PRE-HEARING  
GROUND-WATER DISCHARGE PLAN ANALYSIS  
for  
HOMESTAKE'S URANIUM MILL NEAR  
MILAN, NEW MEXICO  
HOMESTAKE MINING COMPANY

GROUND WATER SECTION  
GROUND WATER QUALITY AND HAZARDOUS WASTE BUREAU  
NEW MEXICO ENVIRONMENTAL IMPROVEMENT DIVISION

January 1984

FIGURE 11. PREDICTED WATER-LEVEL ELEVATIONS, AFTER 110 DAYS OF MURRAY ACRES INJECTION

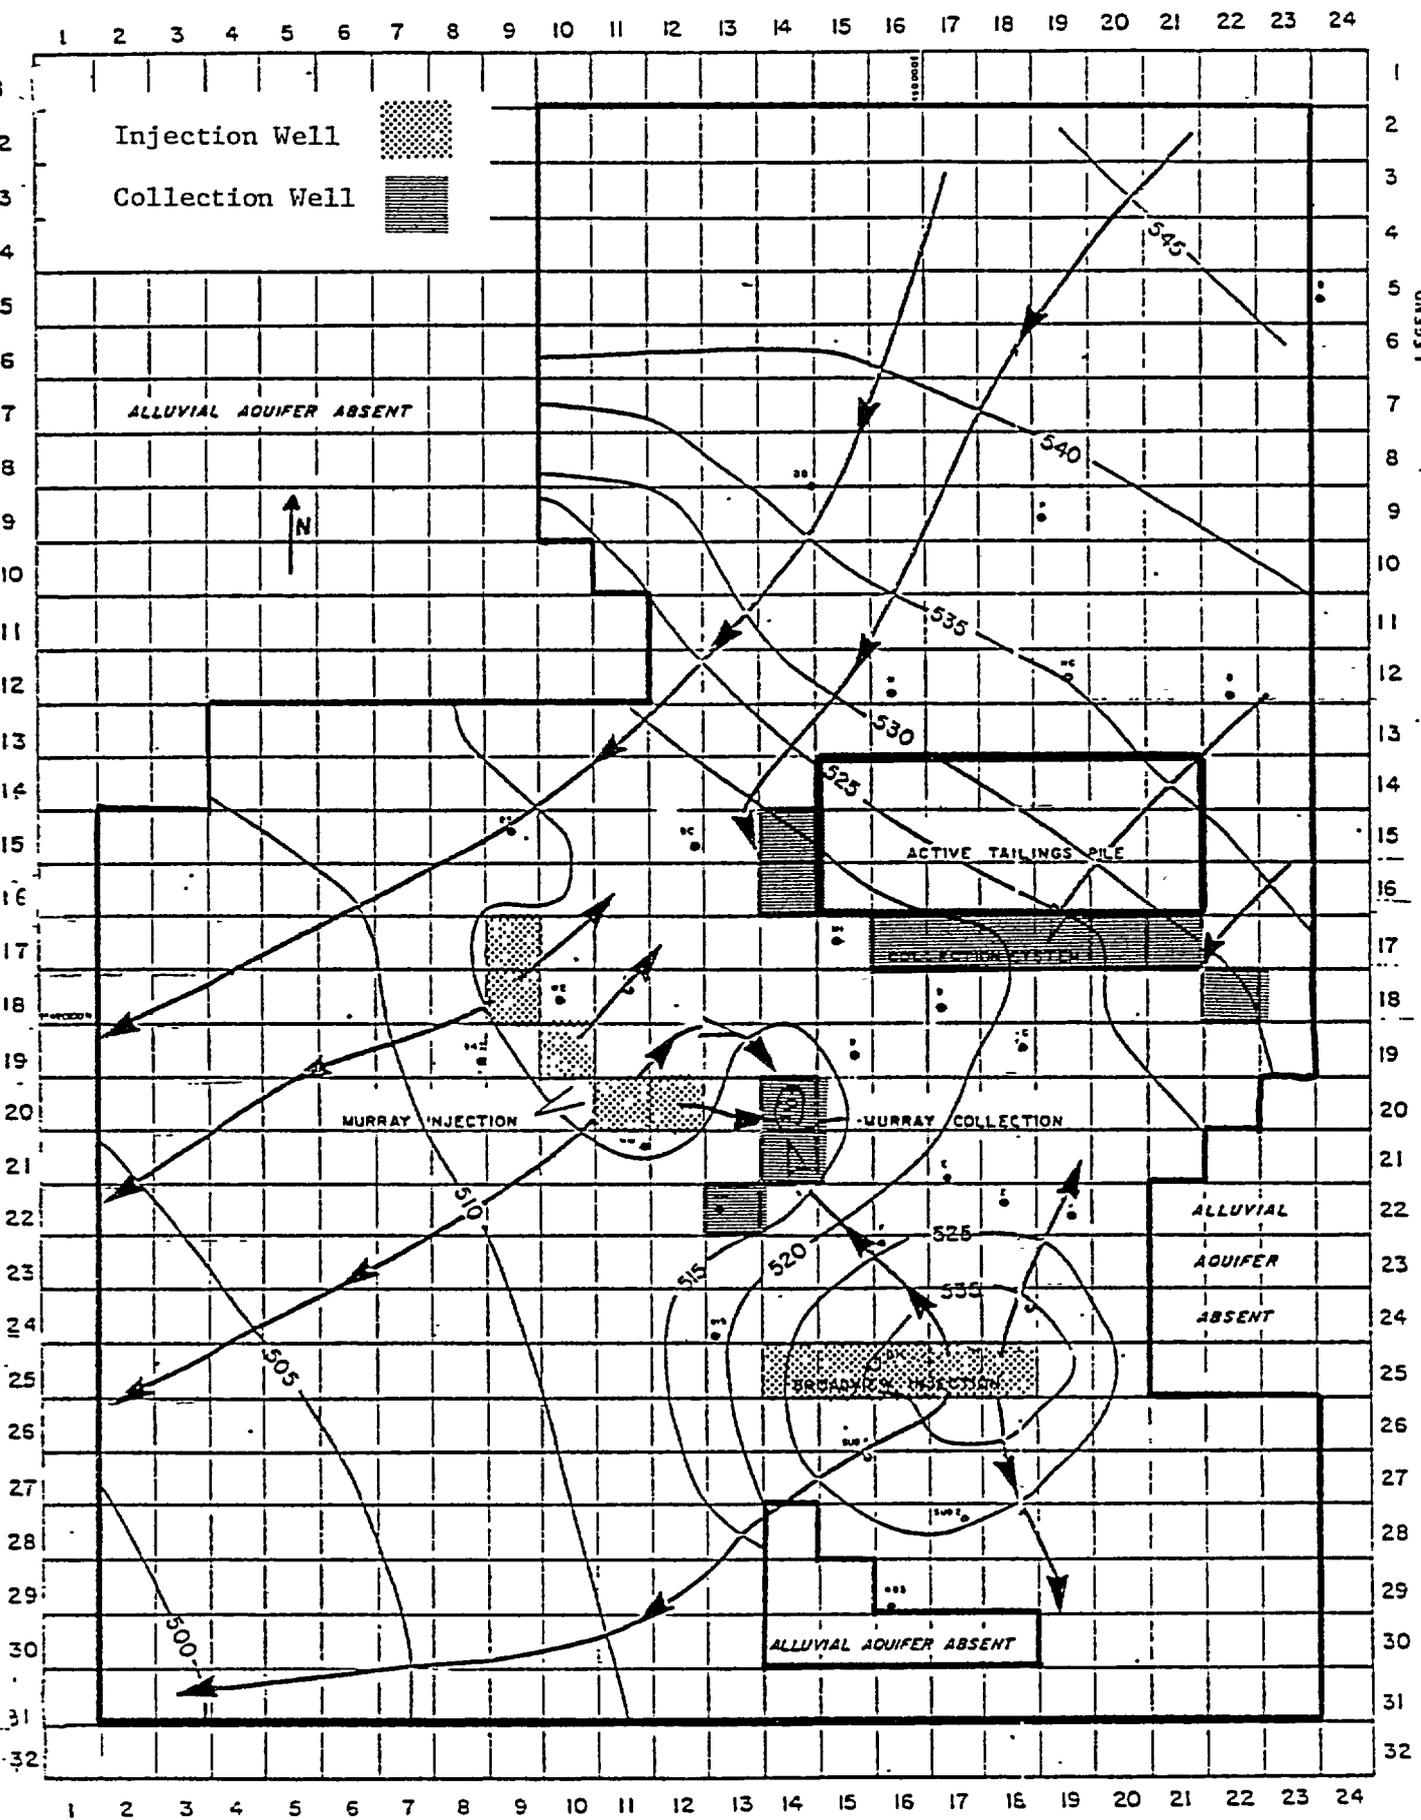
Figure 11 shows predicted water-level elevations at 110 days after beginning operation of the Murray Acres injection system (Nov. 1982). Injection of water at a rate of 300 gpm quickly reverses the ground-water flow direction northeast of the Murray Acres injection line to a distance mid-way to the tailings collection wells. Actual reversal of the ground-water gradient is expected to be significantly quicker than suggested by the simulation, because the water-level elevation calibration lagged the observed water-level increases in Broadview Acres. Figure 11 also shows that the San Mateo alluvial ground-water flow down-gradient of the active-tailings reservoir is completely reversed except for the flow lines which converge on

FIGURE 12. PREDICTED WATER-LEVEL ELEVATIONS FOR NOVEMBER, 1984

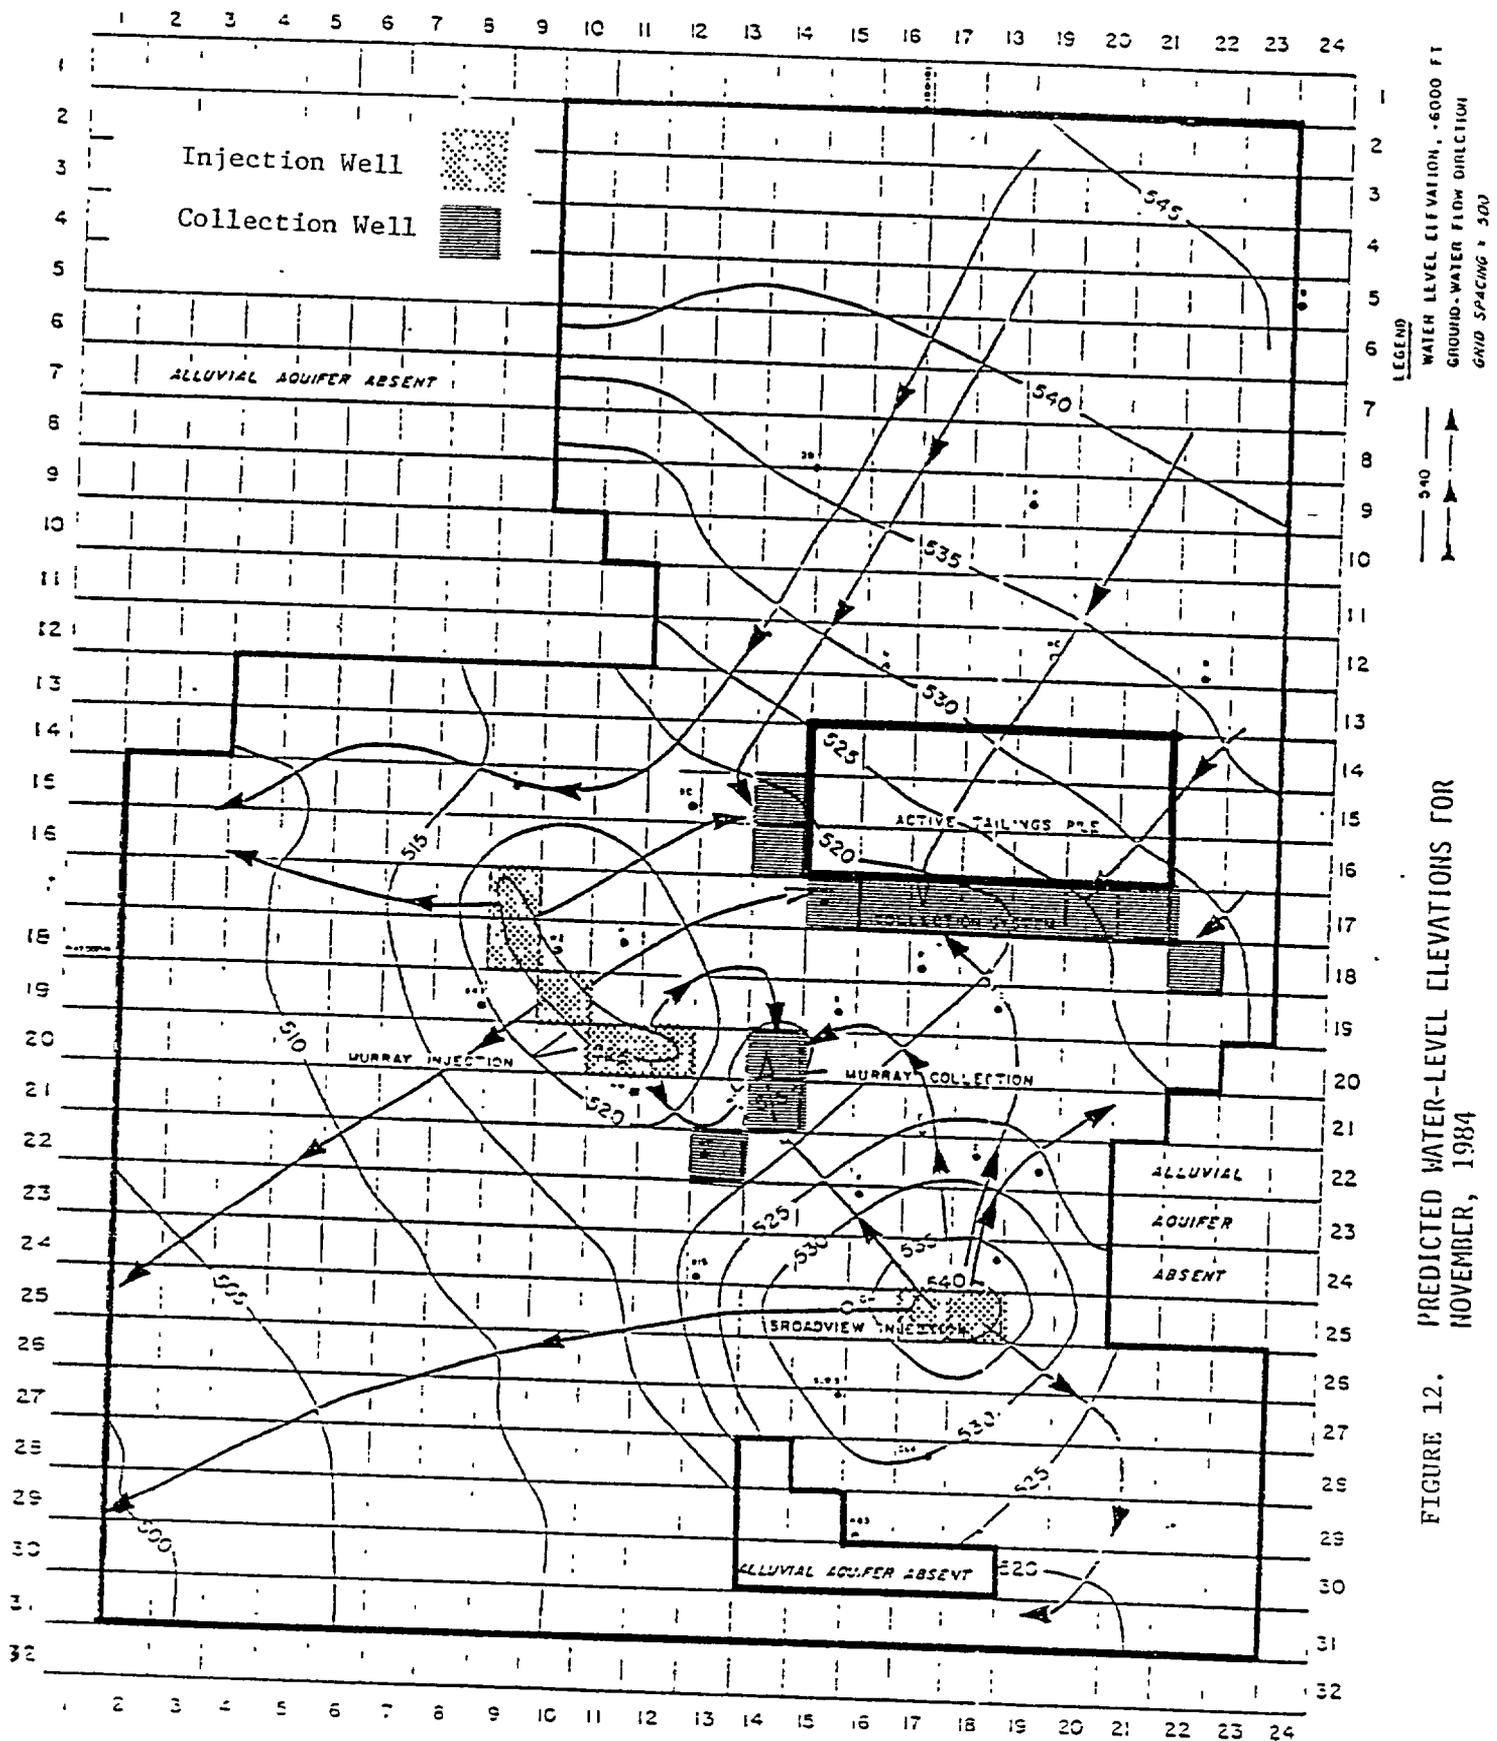
Predicted water-level elevations for November 1984 (Figure 12) 2 years after operation of the Murray Acres injection system at 300 gpm, indicate a significant increase in the water-level elevations of the alluvial aquifer near Murray Acres. The potentiometric surface has been reversed completely between Murray Acres and the tailings collection wells. Flow direction in the vicinity of the injection wells and the area between Broadview Acres and the tailings collection wells has been reversed except for a small area immediately south of the east end of the tailings-collection wells. The low hydraulic conductivity of the alluvial aquifer in this area delays the potentiometric response.

FIGURE 15. PREDICATED SULFATE CONCENTRATIONS FOR NOVEMBER, 1984

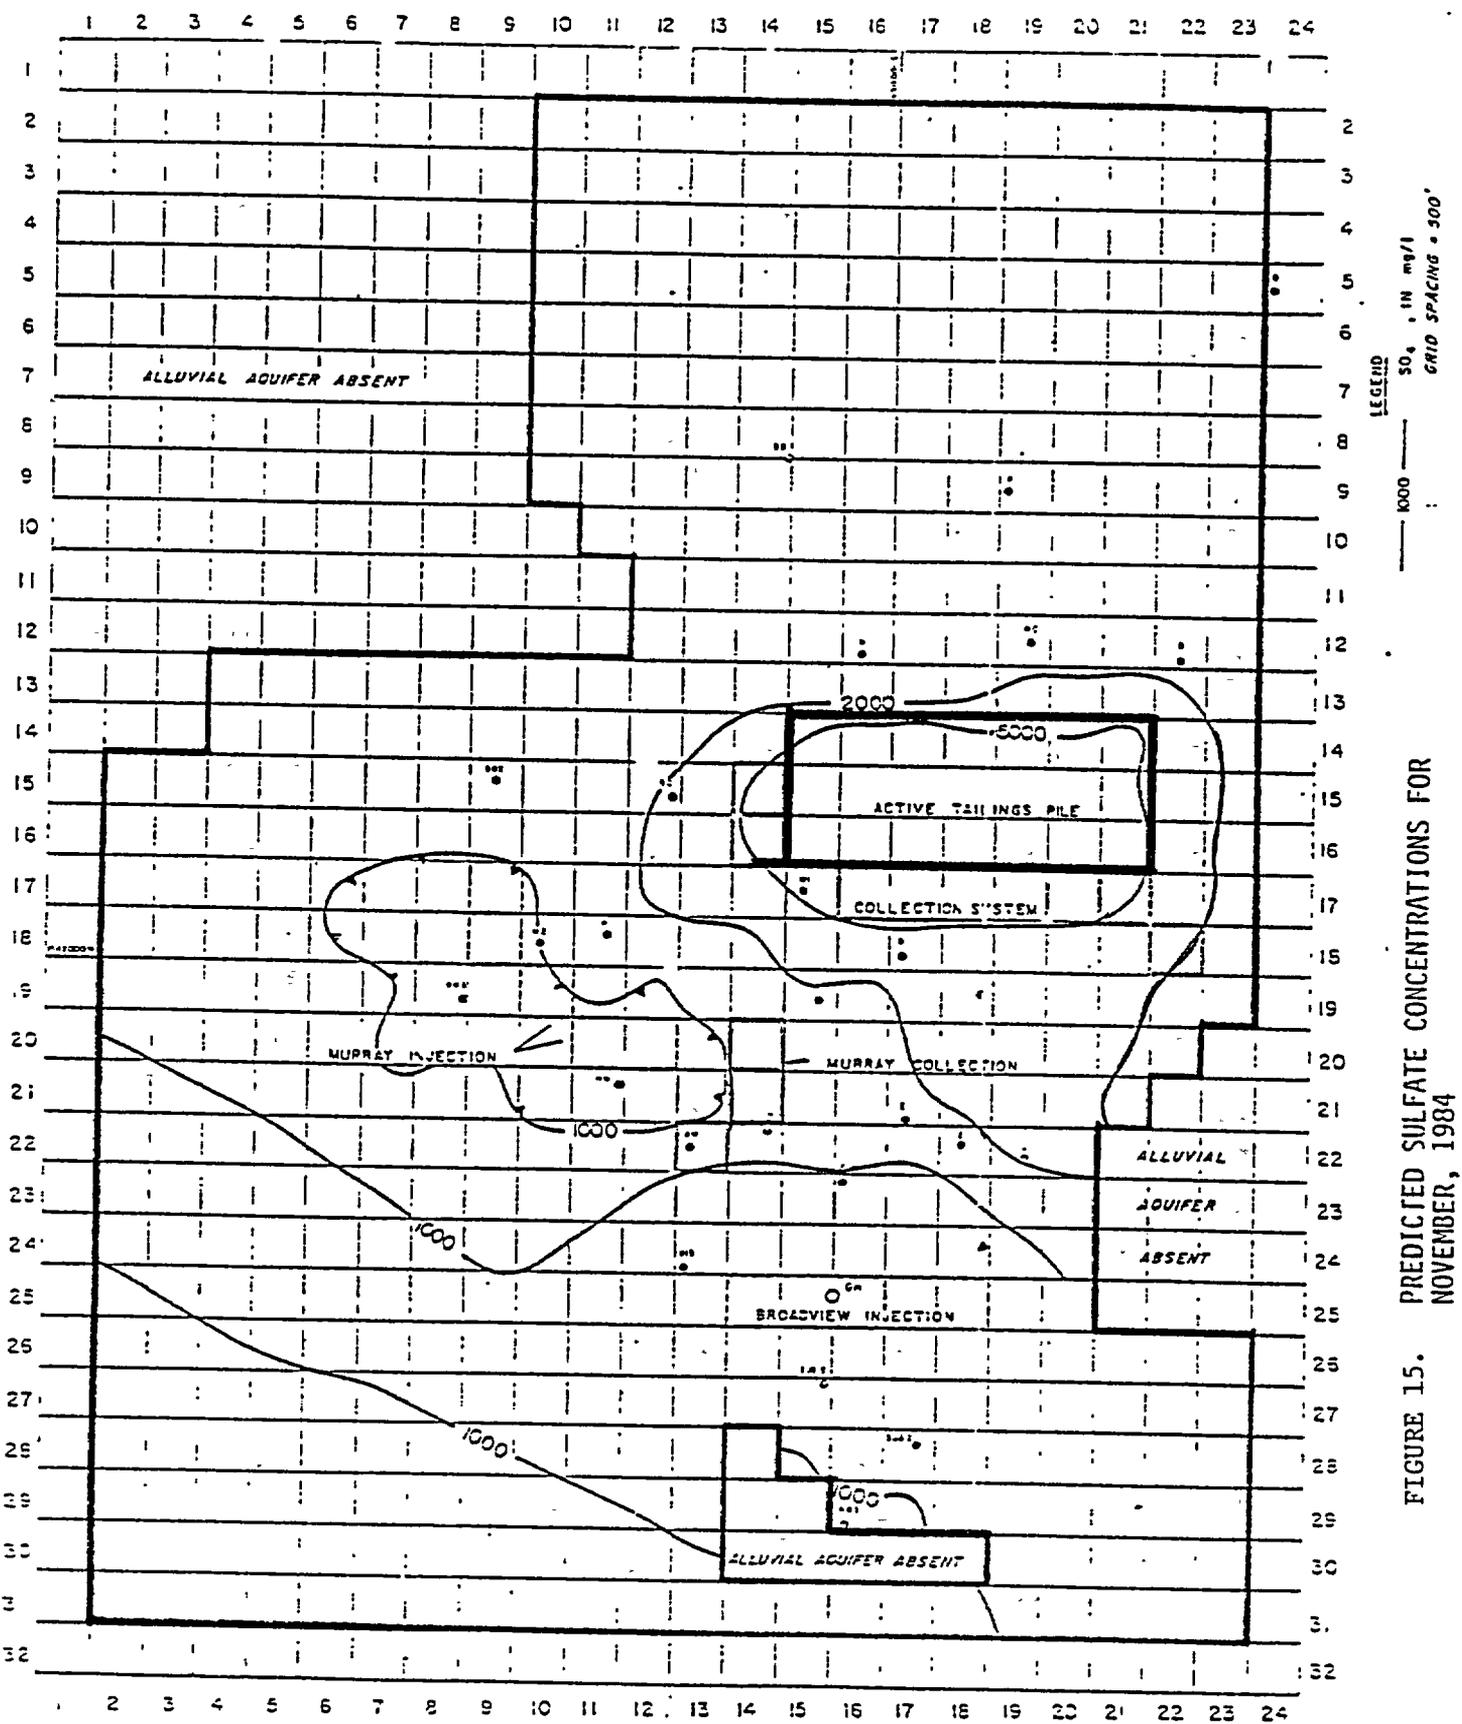
Figure 15 presents predicted sulfate concentrations for November 1984. These contours show a large improvement in concentrations in southern Broadview Acres. Sulfate concentration in the grid in which well Sub 2 is located is predicted to be 672 mg/l. Some concentrations in Felice Acres south of Sub 2 are still slightly above 1000 mg/l, but these concentrations exist in grids in which flow is nearly stagnant. All sulfate concentrations in the alluvial aquifer in Felice Acres should be below 1000 mg/l unless the geometry of the aquifer is such that the ground water is stagnant. The highest sulfate concentration (1390 mg/l) in Murray Acres and Pleasant Valley Estates is predicted to be along the western edge of

Pleasant Valley Estates, where the present concentration is 1750 mg/l. High concentrations in the northeast corner of Murray Acres should be decreased to the range of 1200 mg/l by this time (Nov. 1984). High concentrations between the sub-, divisions and the active-tailings reservoir have been pushed closer to the active-tailings reservoir.

FIGURE 21. PREDICTED SELENIUM CONCENTRATIONS 1000 FEET DOWNGRADIENT OF FELICE ACRES

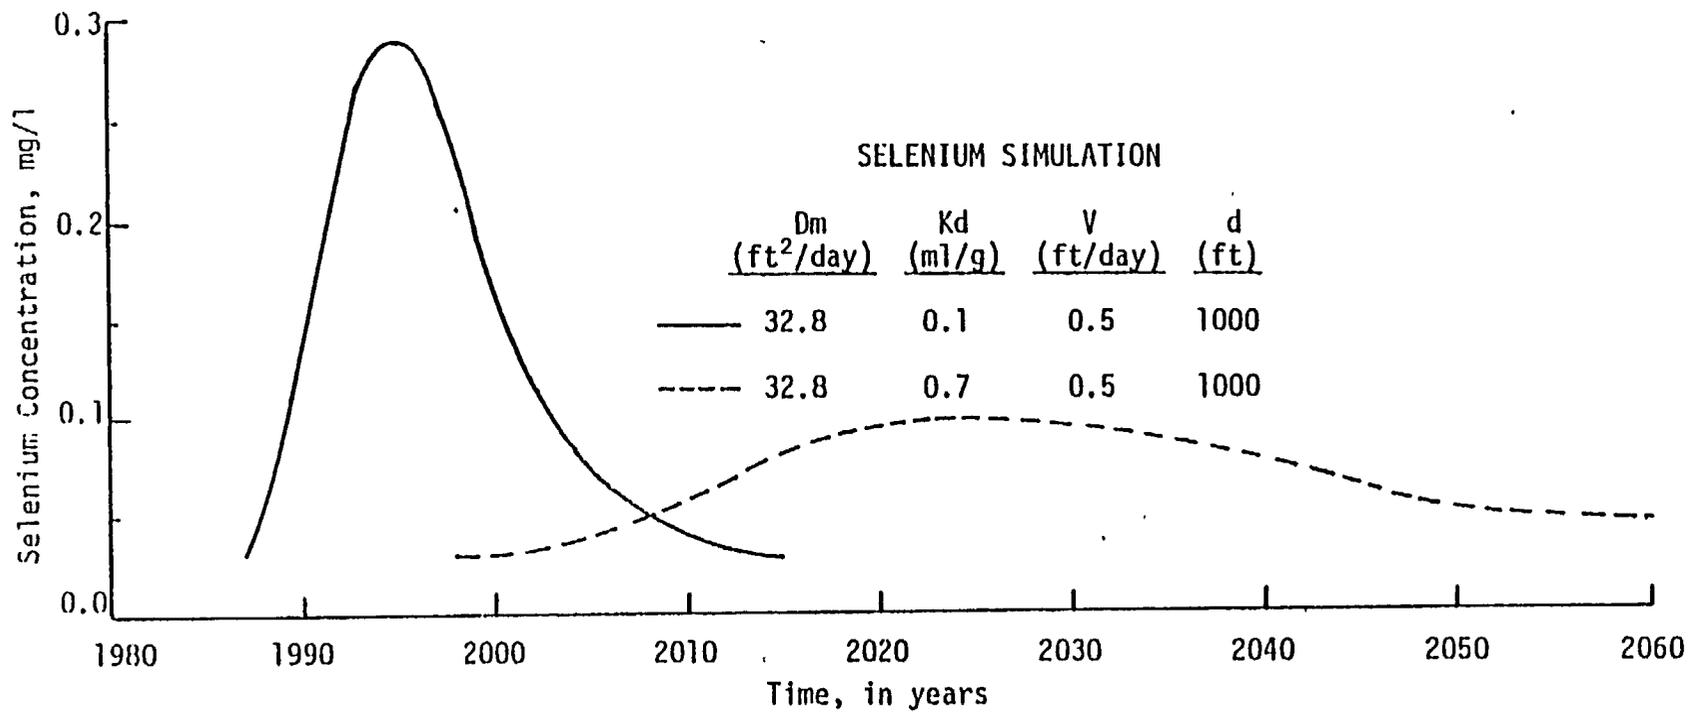
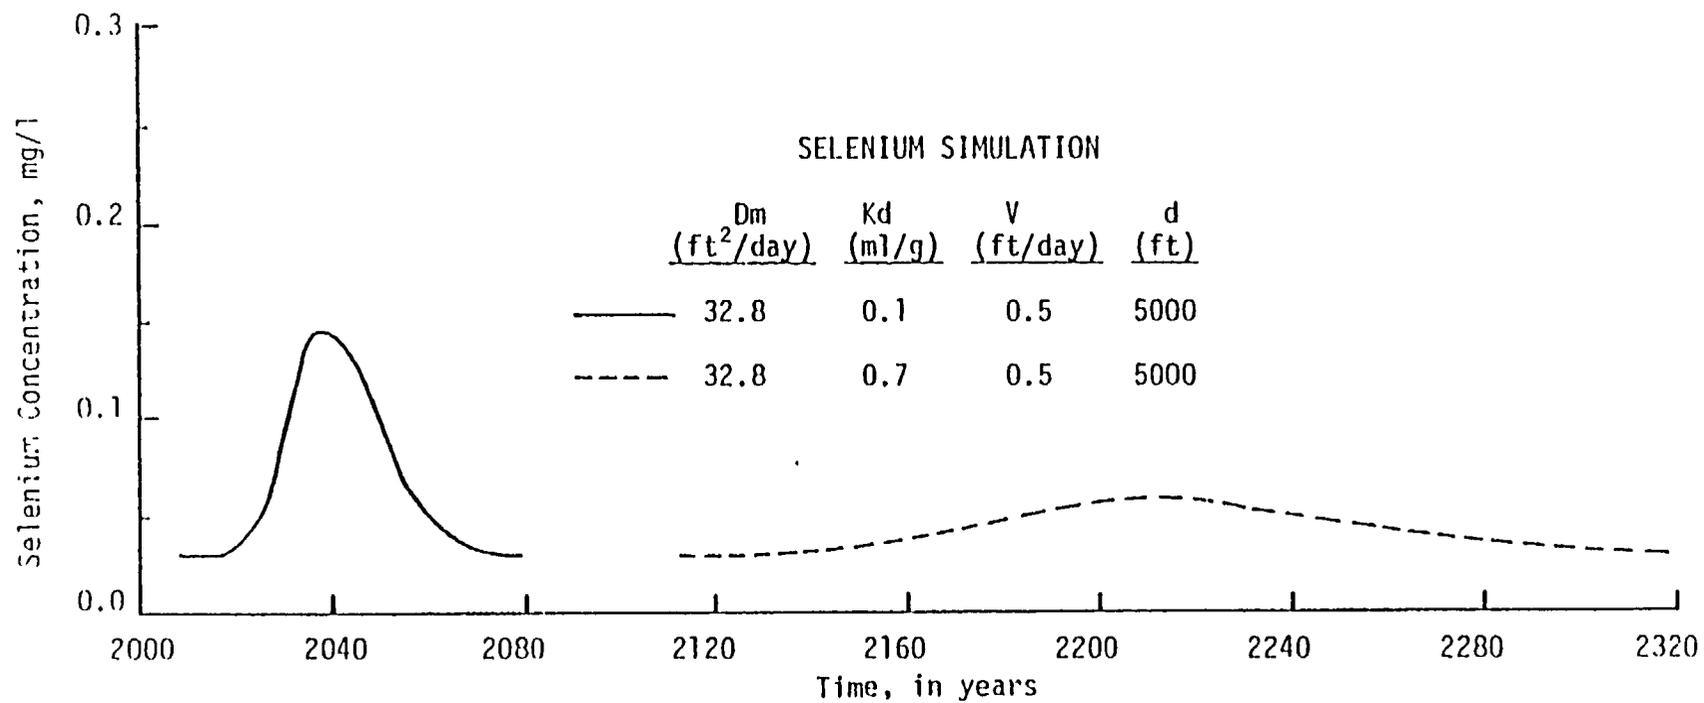
The U.S.G.S. solute transport numerical model was also used by the EID to determine the accuracy of parameters used in the Homestake model. Simulation involved the use of the same grid spacing and aquifer parameters. However, discharge was added for the inactive-tailings reservoir and the water table was calibrated using a constant head rather than constant flux boundary. Results of the EID simulation indicate that

the observed sulfate distribution cannot be calibrated if the active-tailings reservoir seepage is 150 gpm and the inactive-tailings reservoir is assumed to discharge at 75 gpm. The reason for this is that high concentrations move farther down-gradient than actually observed. Therefore, Homestake's use of 75 gpm, discharging from the active-tailings reservoir and no discharge from the inactive-tailings reservoir, appears to be valid. However, the EID calibration was not able to match the extent of sulfate attenuation down-gradient in Broadview, Murray and Felice acres with the dispersivities and concentrations in the discharge used by Homestake in their ground-water model. This implies that the two-dimensional model may be influenced by movement in the 3rd or vertical-dimension. The fact that tailings seepage has reached ground water in the upper Chinle substantiates that this is occurring.

Because Homestake accounted for this discrepancy by changing discharge rates and concentrations until the model was calibrated, the flow system and concentration distribution projections are probably correct. However, the modeled seepage rates and concentrations are probably lower than actual rates and concentrations because of flow in the 3rd-dimension which was not accounted for in the Homestake model.
